**Appendix G:**

Graphic Representation of the Relationship Between Haleʻiwa Beach House Project Site  
and Previous Cultural Impact Assessment Studies, Haleʻiwa, Oʻahu  
(Garcia and Associates, February 2, 2018).

## HALE`IWA BEACH HOUSE

**Appendix J:**  
Draft EA Comment and Response Letters

Figure 2. Site Plan

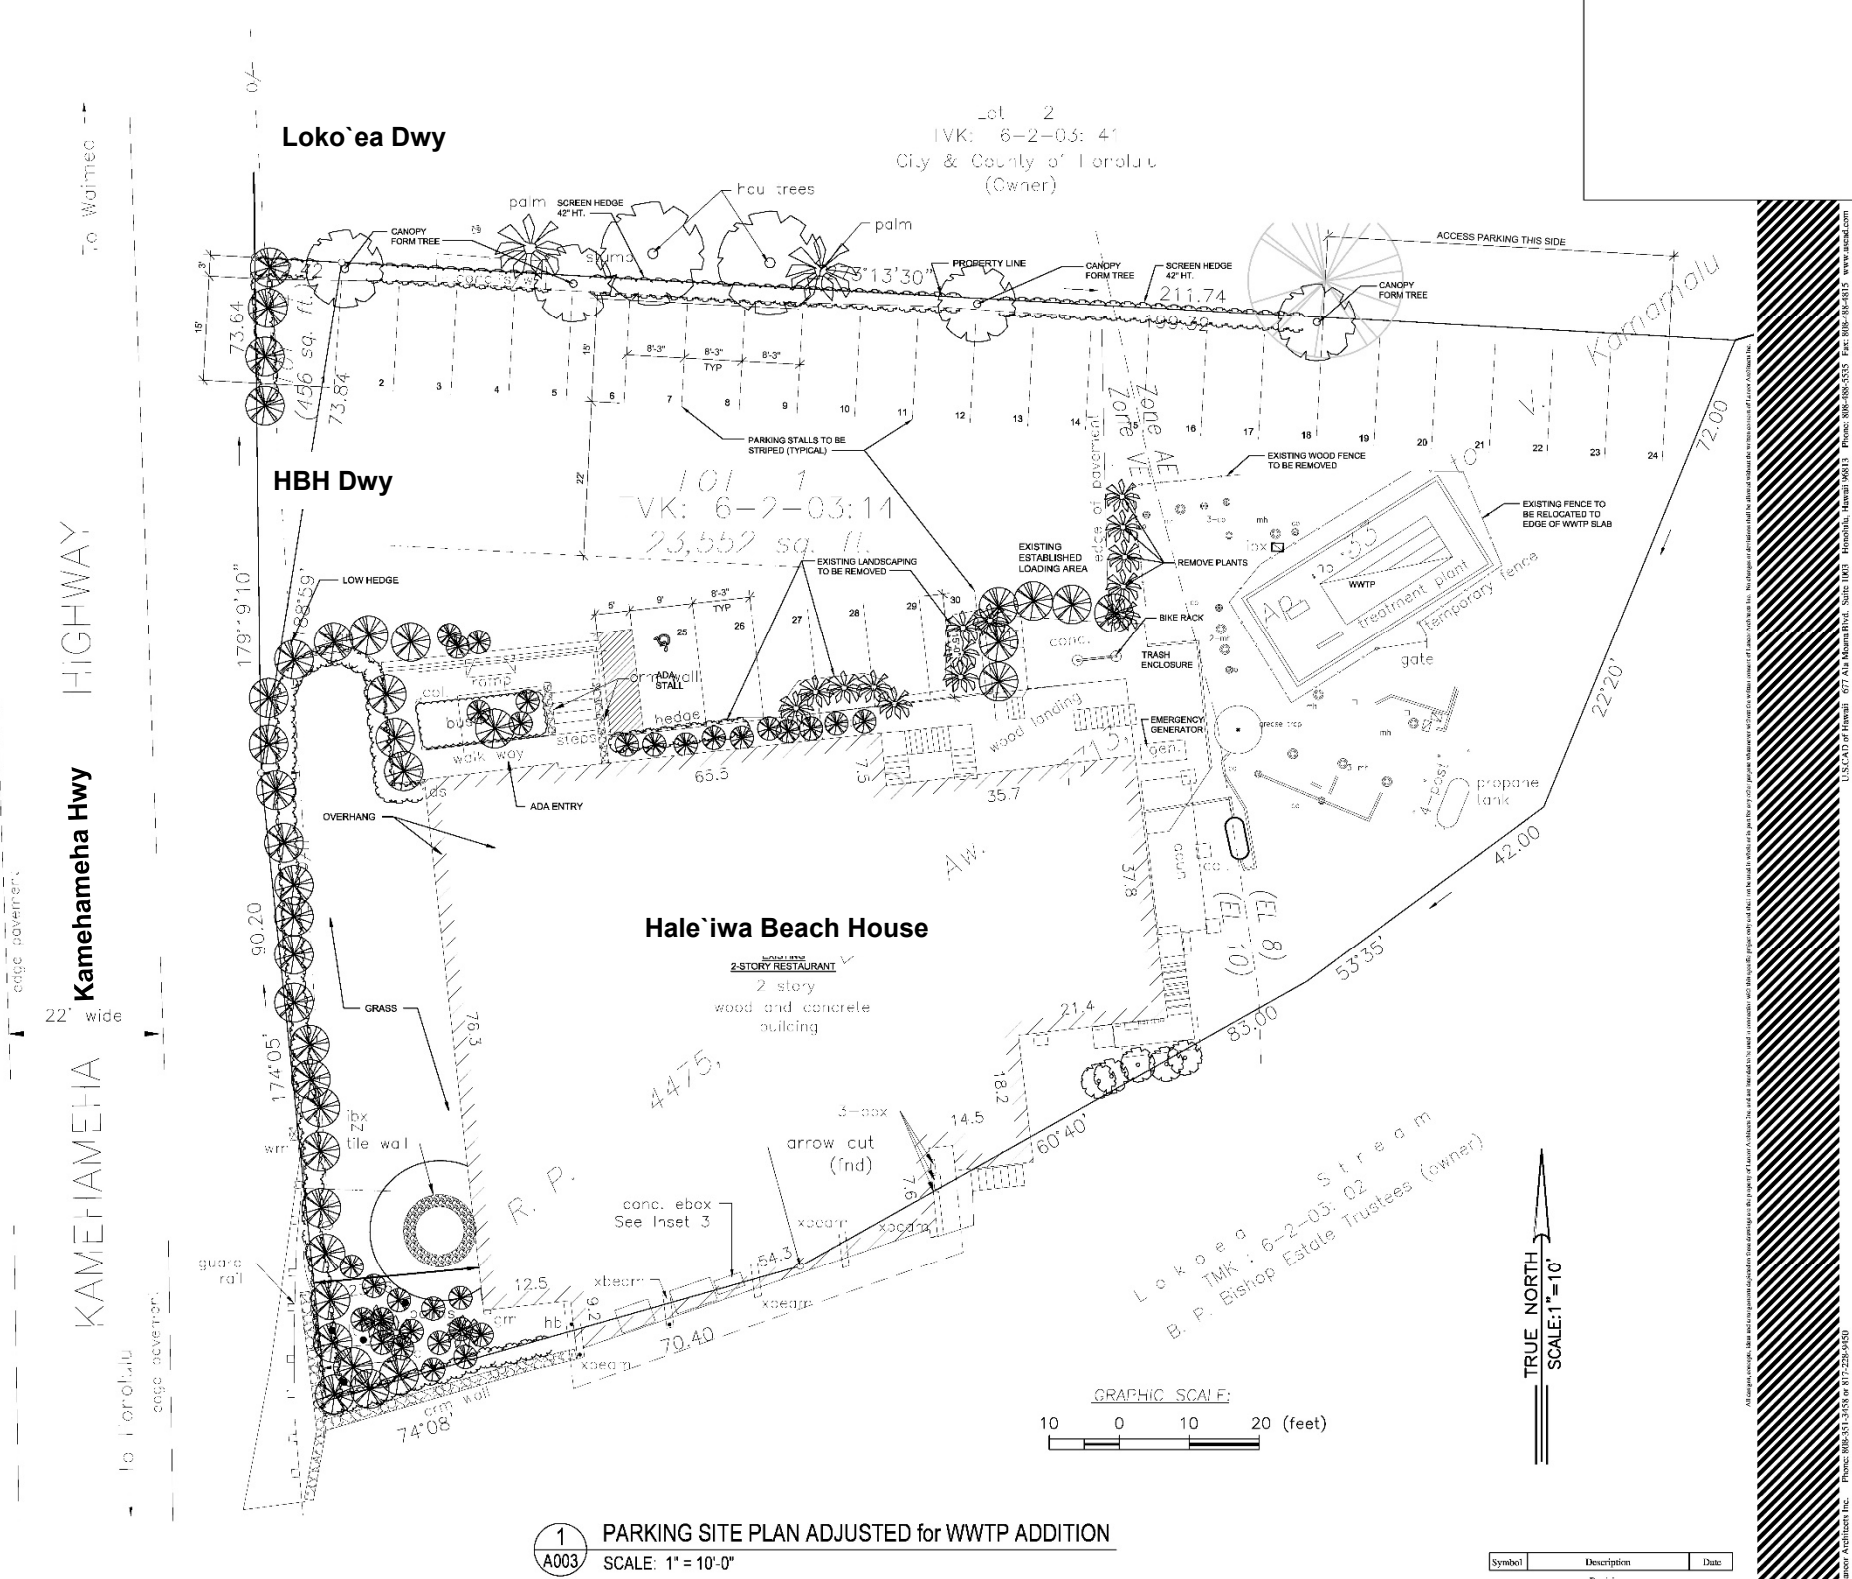
15. In Figures 2-2 and 2-3, show the road widening setback and required front yard.
16. Provide building elevations or sections showing the building heights, 40-foot height limit, height setbacks, required yards, and property lines.

The Applicant added the road widening setback to Figures 2-2 and 2-3 based on the site plan provided in the approved SMA Permit (minor) 2014/SMA-22. Figures 2-2 and 2-3 are also revised to show the required front yard based on a 10-foot offset from the existing property line.

Figure 3. Existing Weekday Peak Hour Traffic

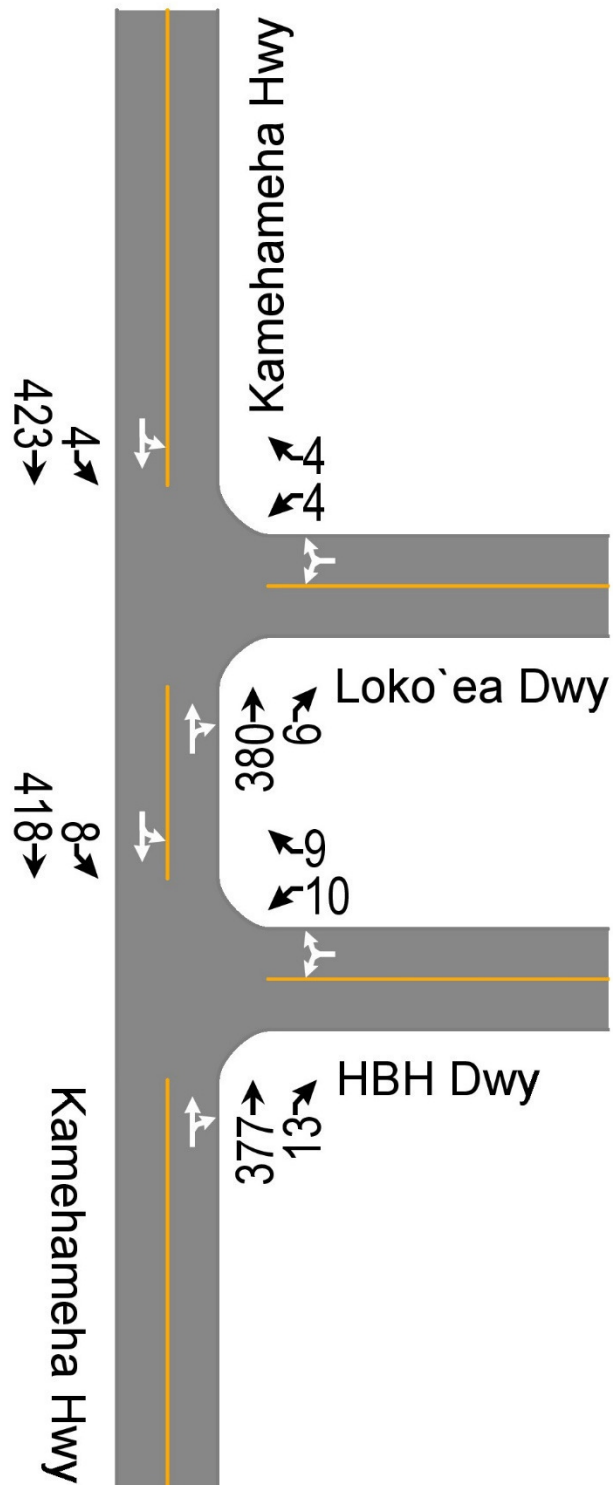
- d. Existing Weekday Peak Hour Traffic (page 8) includes a discussion on weekday traffic generated in both directions at the Haleiwa Beach House and Lokoea Driveways. The figures do not match with what is shown in Figure 3 (page 9).*

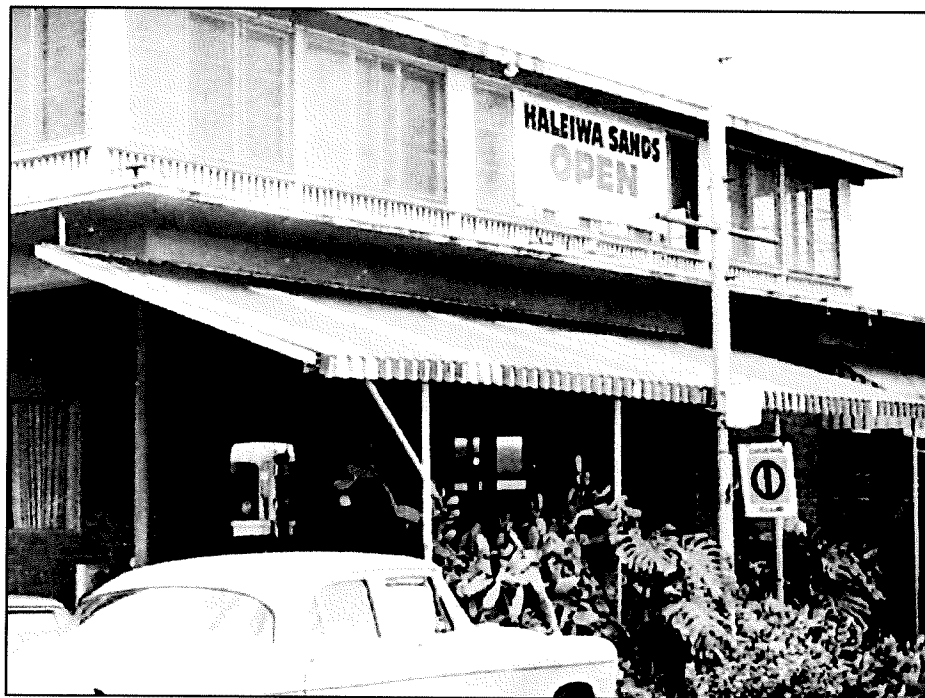
- d. In Figure 2-3 on Page 2-13, the concrete work along the border of Loko Ea streambed also appears to have expanded beyond the existing building footprint with the addition of at least two concrete footings into the sandy Loko Ea streambed.*

- e. On Page 4-15, the Applicant references these encroachments onto the adjacent parcel owned by Kamehameha Schools, zoned AG-1. Please explain how this will be rectified.*

- f. The extent of the encroachment, the admitted expansion of the building footprint, as well as new concrete and foundation work at several places around the perimeter of the building, also appear to be represented in the photographs shown in Appendices A.1 and A.2. Please clarify these discrepancies.*

As disclosed in the response to Question 6, the floor area added to the building footprint is 611 square feet from the covered ADA front entryway (250 sf) on the north side of the building and the enclosed code-required fire exit stairway (200 sf) on the south side of the building and the freezer (161 sf).

- a. The "new covered deck" and "reconstructed concrete lanai seating area" refer to the same improvement which is the ground level area at the front of the restaurant. This area is included in the architect's floor area calculation.
